DEVELOPMENT REVIEW BOARD
SUPPLEMENTAL SUBMITTAL

PROJECT NO. PR-2021-006238

Application No. SI-2021-01916

Re: Allaso Louisiana Site Plan – DRB Comment Responses (PR-2021-006238)

SHEET NO
SDP5.1

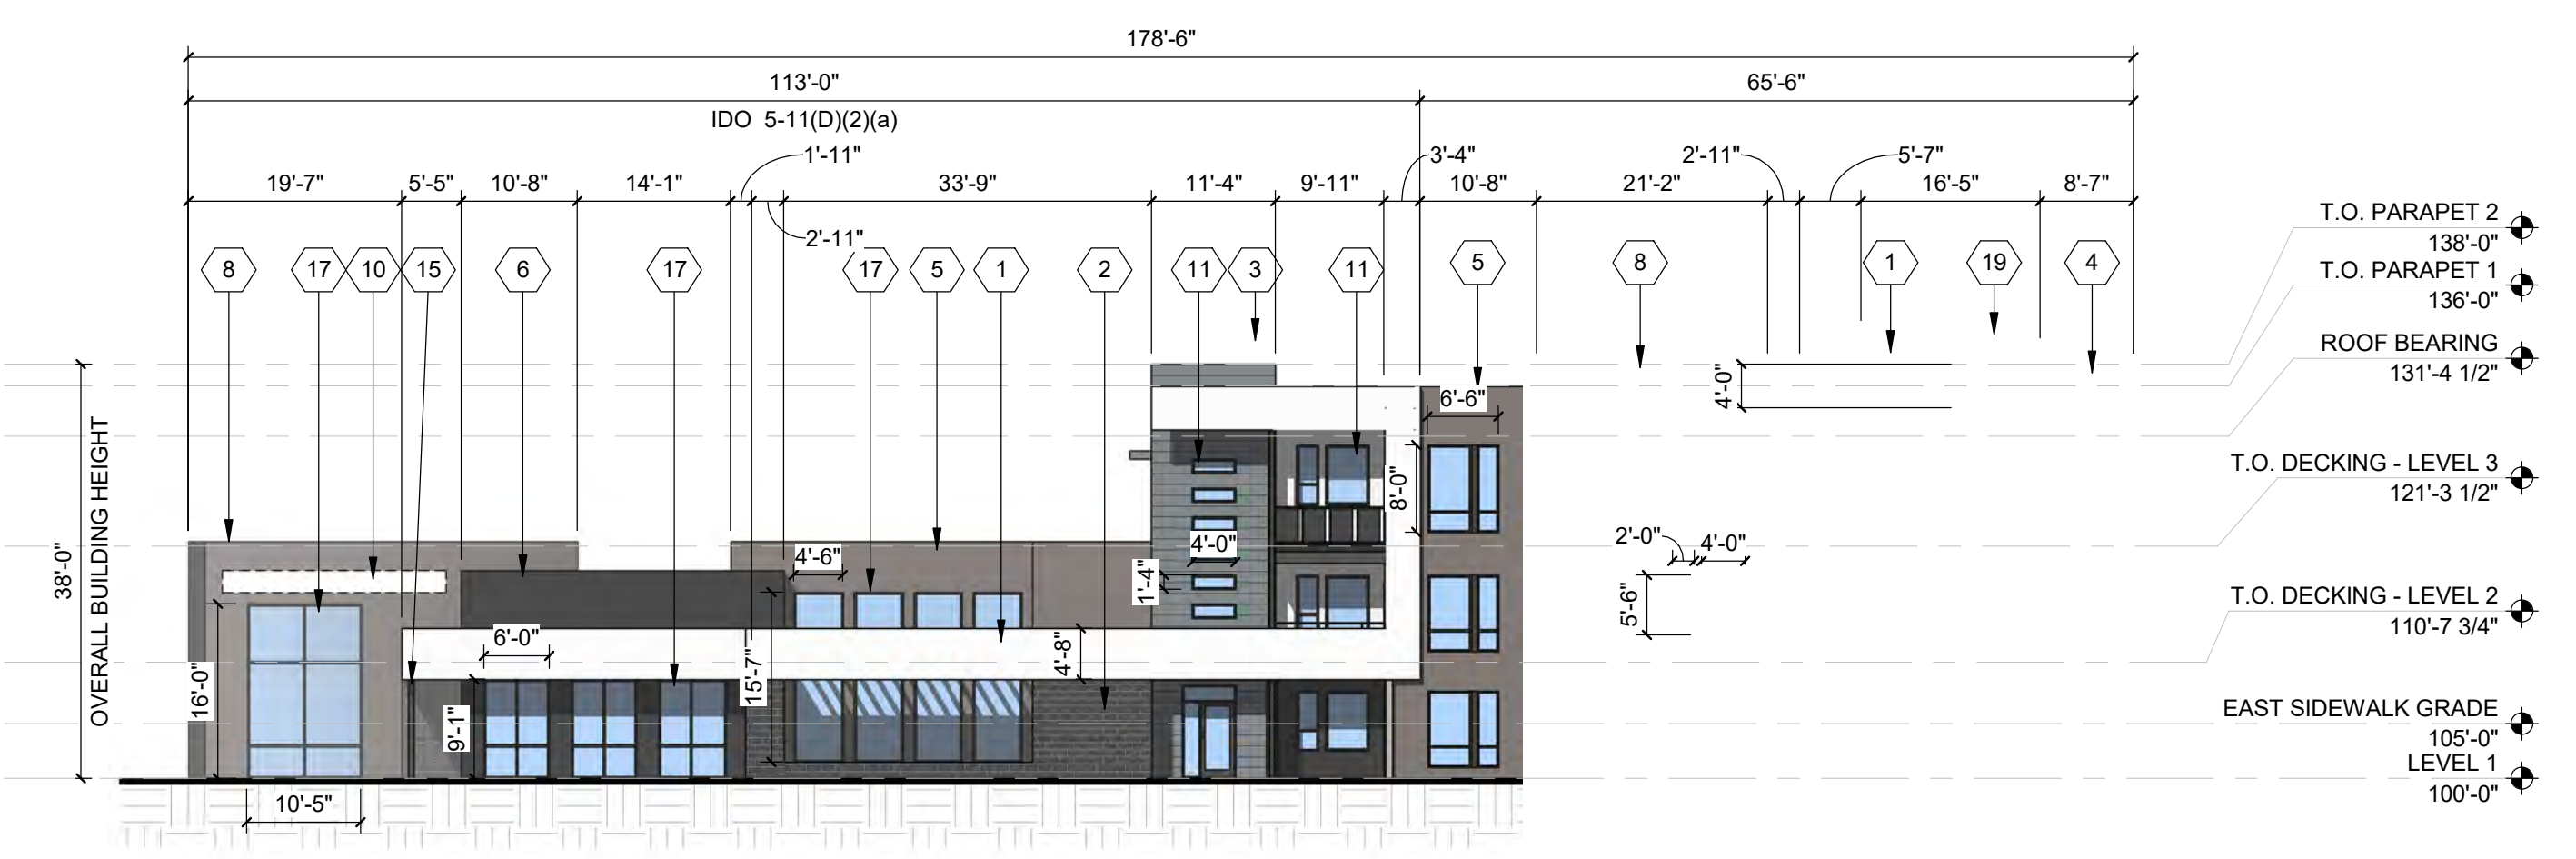
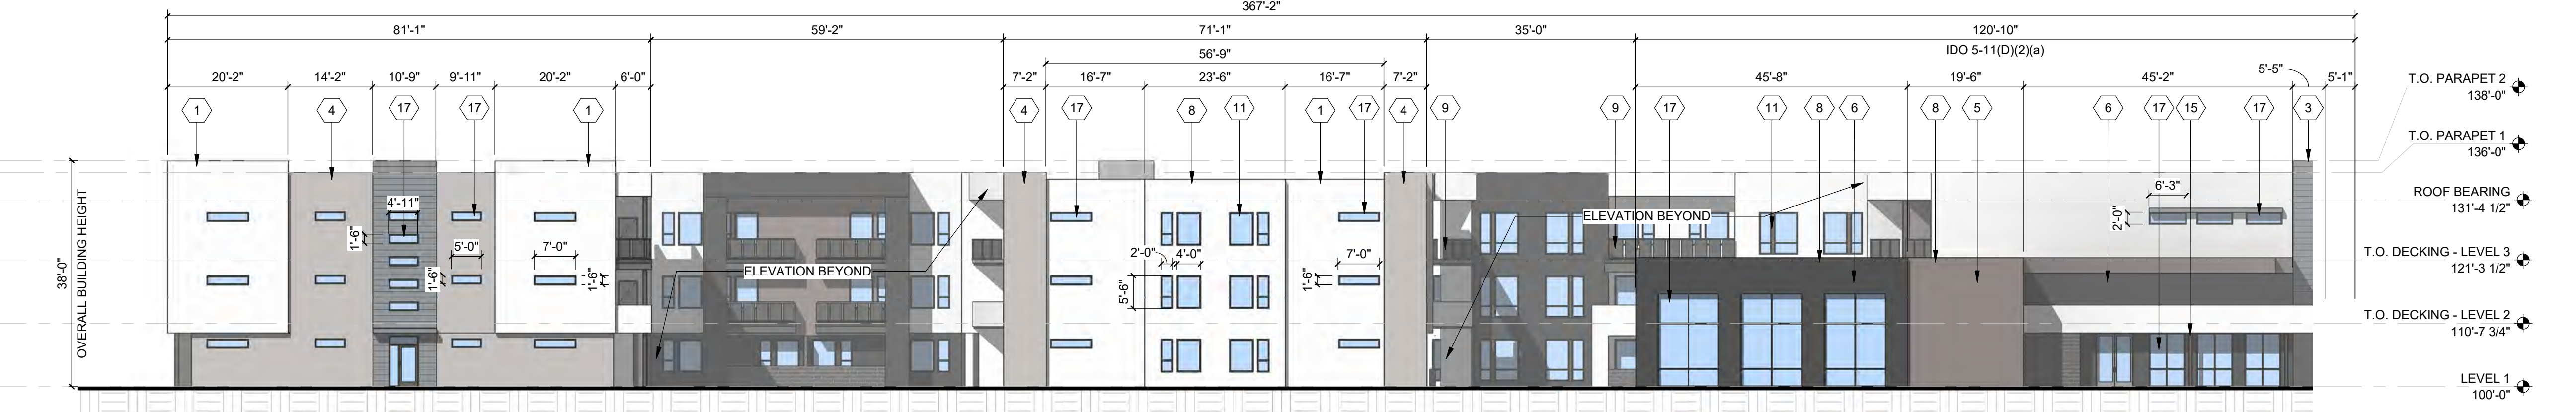
10. The building facades must meet 5-11(D) of the IDO. Provide a comment response letter explaining how the requirements of 5-11(D) are being met.
 - a. **A note has been added to the elevations demonstrating compliance with the glazing requirements for the street-facing facades. IDO Section 5-11(D) Multi-family Residential Development is met in the following ways:**

- 1. Building entrances are emphasized by contemporary architectural overhangs.**
- 2a. The facade design incorporates elements of human scale by incorporating windows that make up 20% of the ground floor of street-facing facades (see calculations on south and east elevations) and are recessed 2 inches on upper floors. Windows facing west have been reduced in size to reduce heat impact or are shaded by balcony structure above or incorporate sunshade devices where needed.**

- 2b. Facade articulation is achieved in combination of recesses and projections every 30 feet minimum (see dimensions on elevations for plane changes), more than one finish material or color is used on every facade (refer to exterior finish legend indicating up to 6 color and material selections), and balconies are incorporated at every dwelling unit for visual interest.**

- 3. Facade length exceeds 60 feet; therefore, roofline extends from 36'-0" to 38'-0" at intervals less than 60 feet continuously.**
- 4. 5-11(D)4 is not applicable.**
